#### GENOA CHARTER TOWNSHIP PLANNING COMMISSION PUBLIC HEARING JUNE 12, 2017 MONDAY 6:30 P.M. AGENDA

Attention:	Kelly Van Marter, AICP
	Planning Director and Assistant Township Manager
Subject:	Genoa Plaza – Site Plan Review #3
Location:	Grand Oaks Drive – vacant parcel at the northwest corner of Grand Oaks and Latson Road
Zoning:	NR-PUD Non-Residential Planned Unit Development District

#### Re: Genoa Plaza Site Plan Review #3

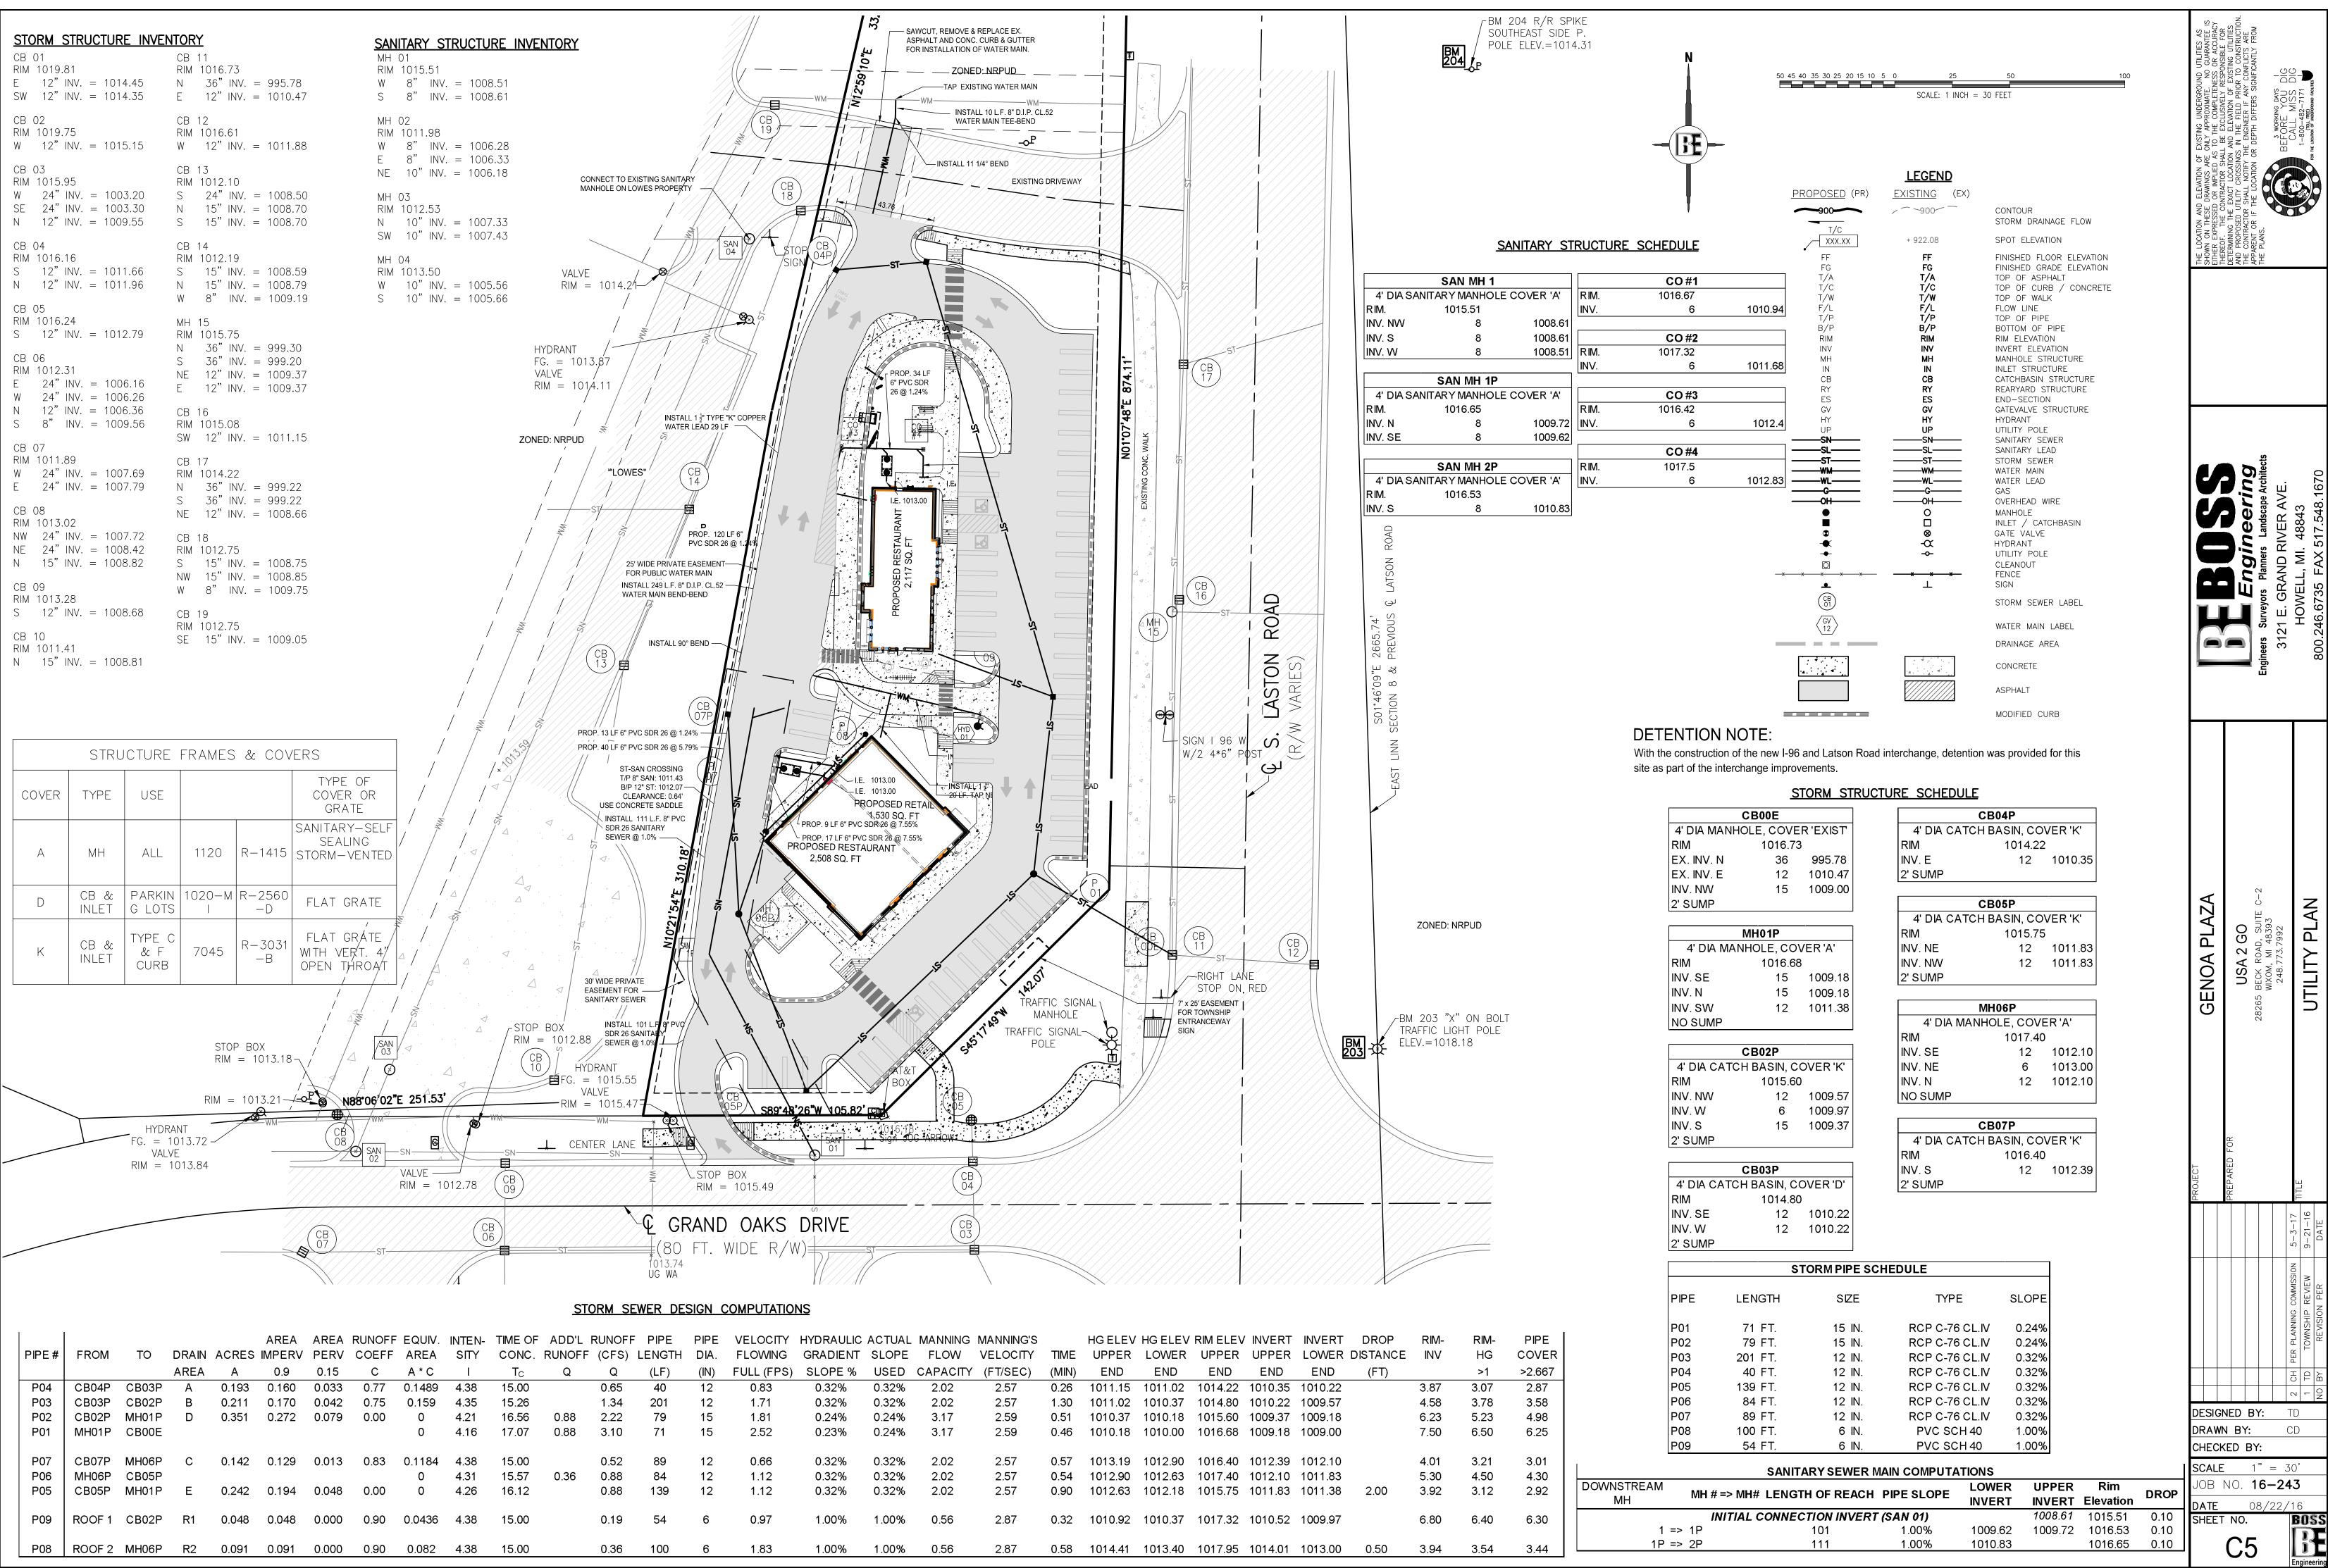
- 2. The weighted runoff coefficient for the site should be added to the drainage area table on sheet C4 so compliance to the site detention waiver conditions, as set forth by Genoa Township on August 22, 2011, can be confirmed.

ISSUED FOR SPA SPA SPA SPA	DATE 02.01.17 02.22.17 05.01.17 05.23.17
DATE : DRAWN : ACA CHECKED : JT SCALE : <b>1'=40'</b> JOB NO : BD-16-237	
SHEET TITLE : SITE LAYOUT PAVING PLAN SHEET C3	_

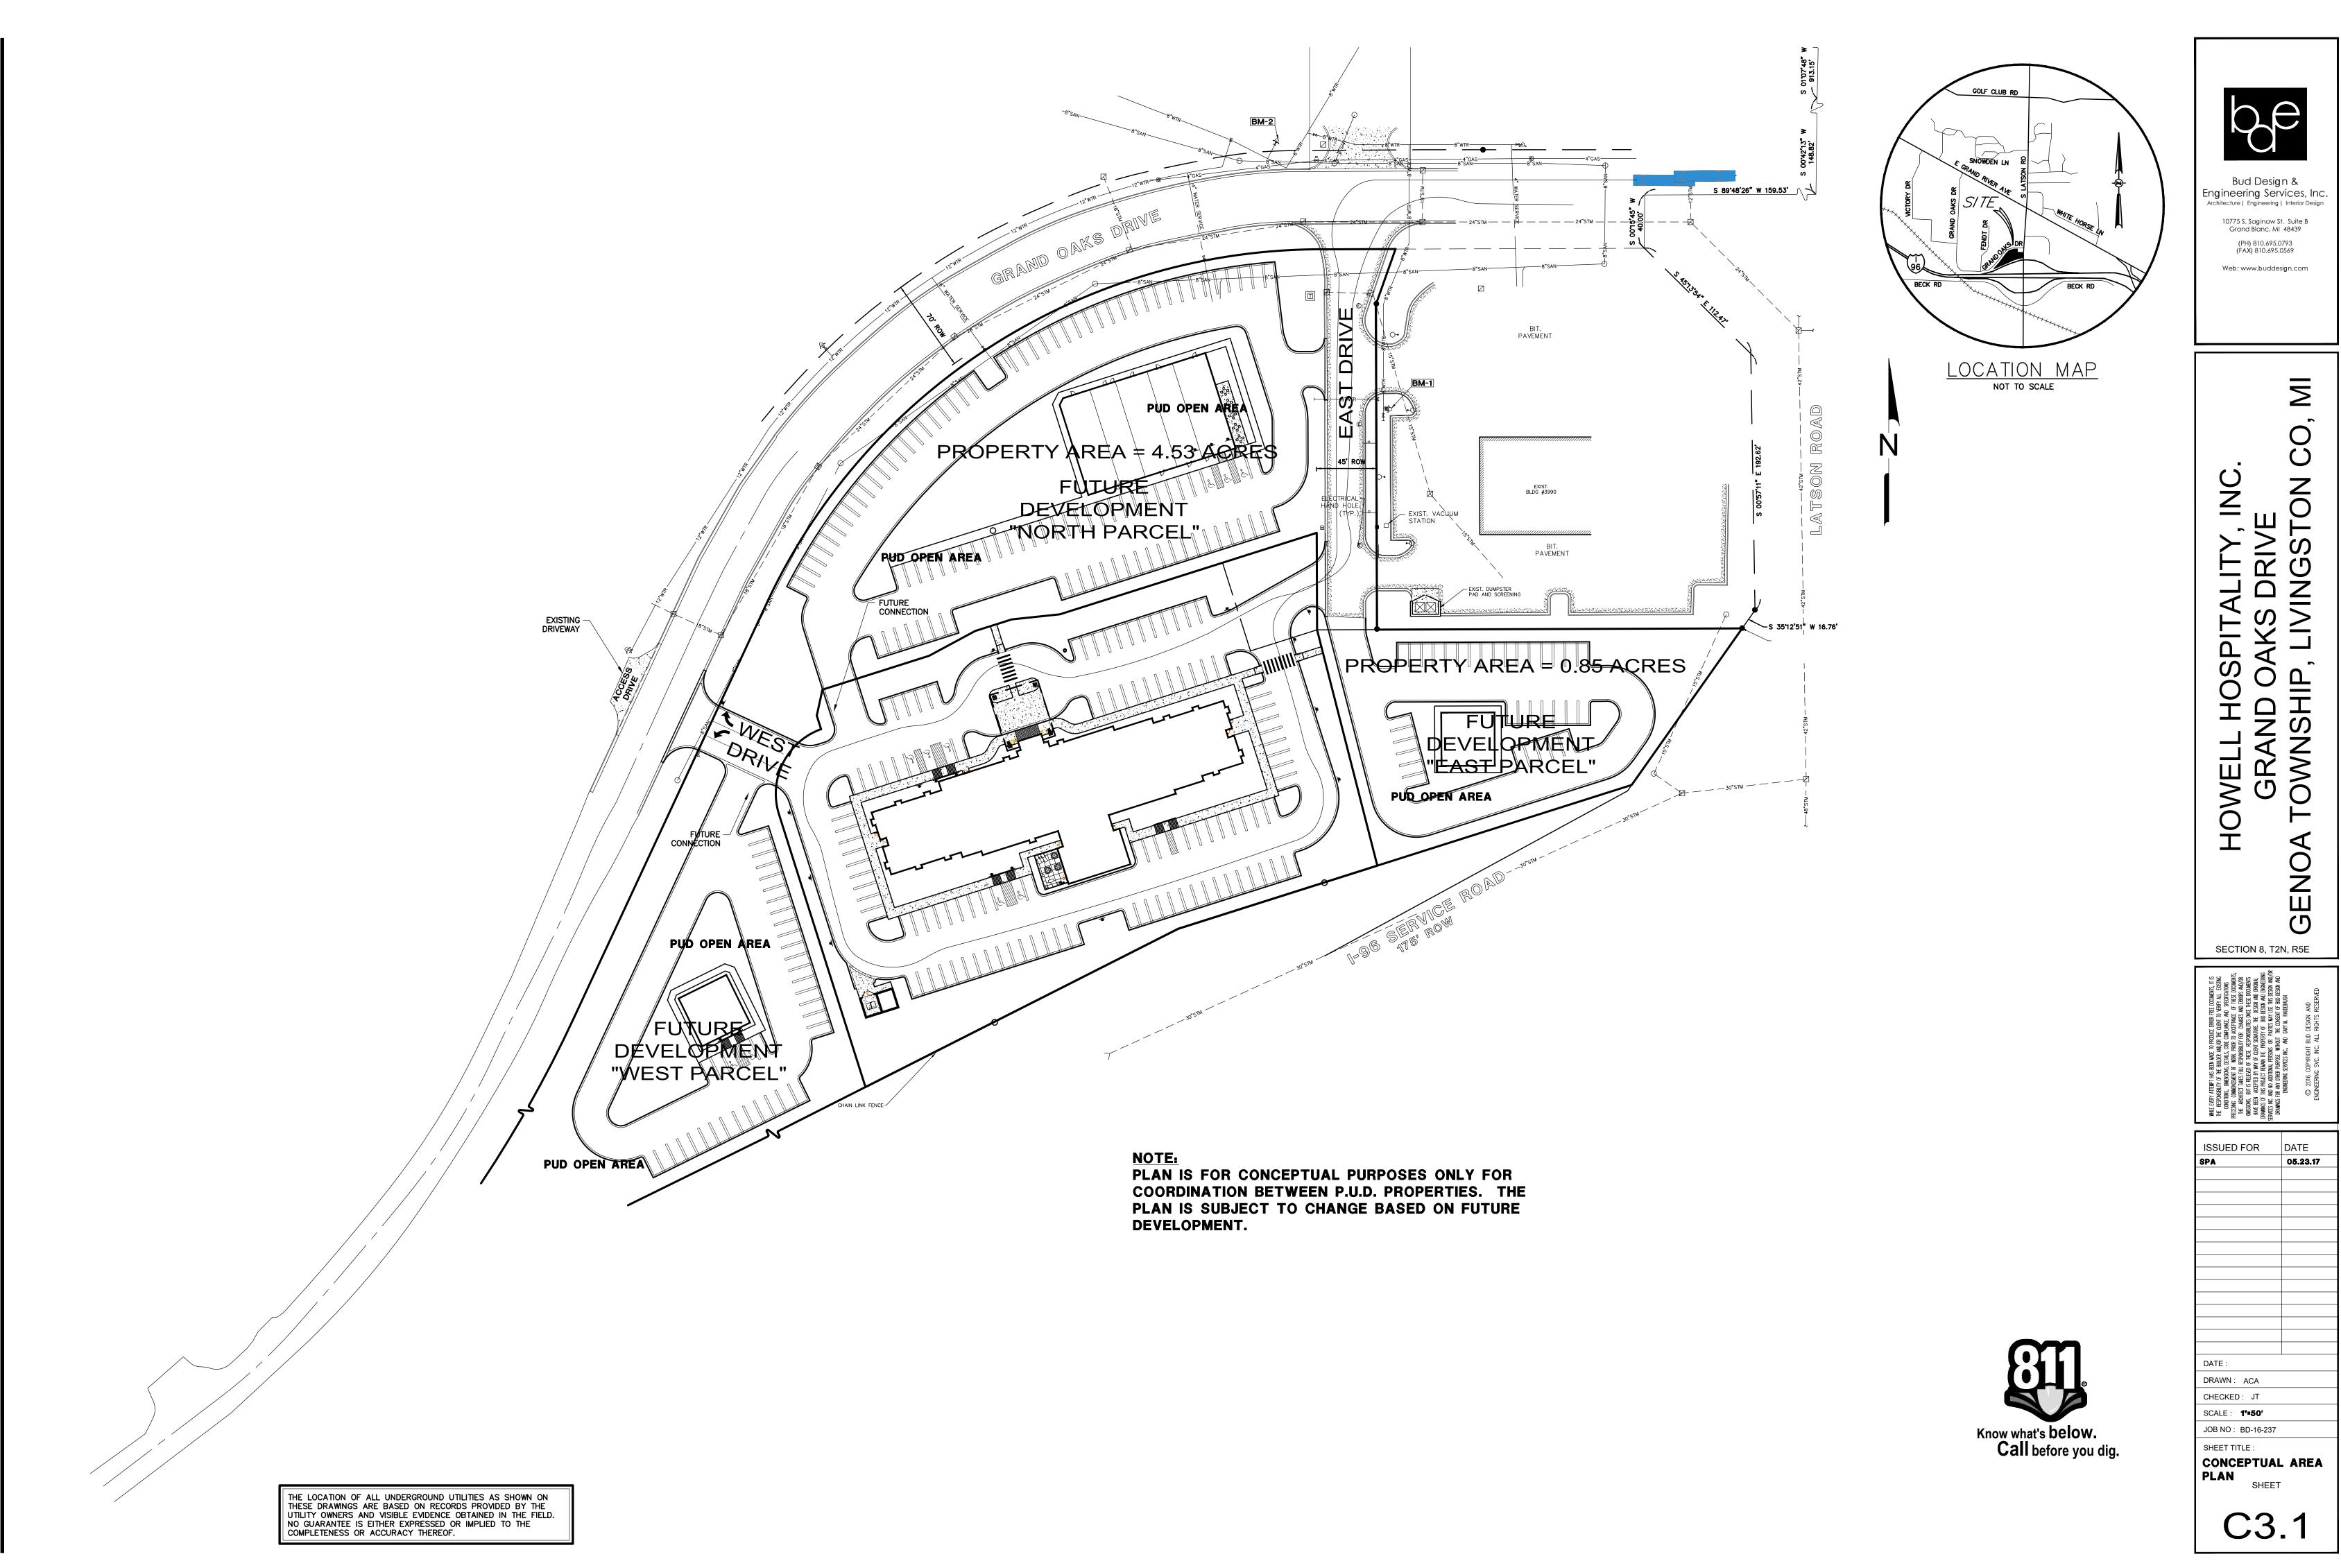
As shown on Sheet C3.1, the cross-access connection was added as a result of discussion at the prior meeting and will provide direct access to the subject site and vacant parcel to the south/west, as well as indirect access to the vacant parcel to the north/east (via the Hampton Inn site). Future connection to the vacant parcel to the north/east will cause the removal of 4 parking spaces; however, the proposed plan has a surplus of 7 spaces.
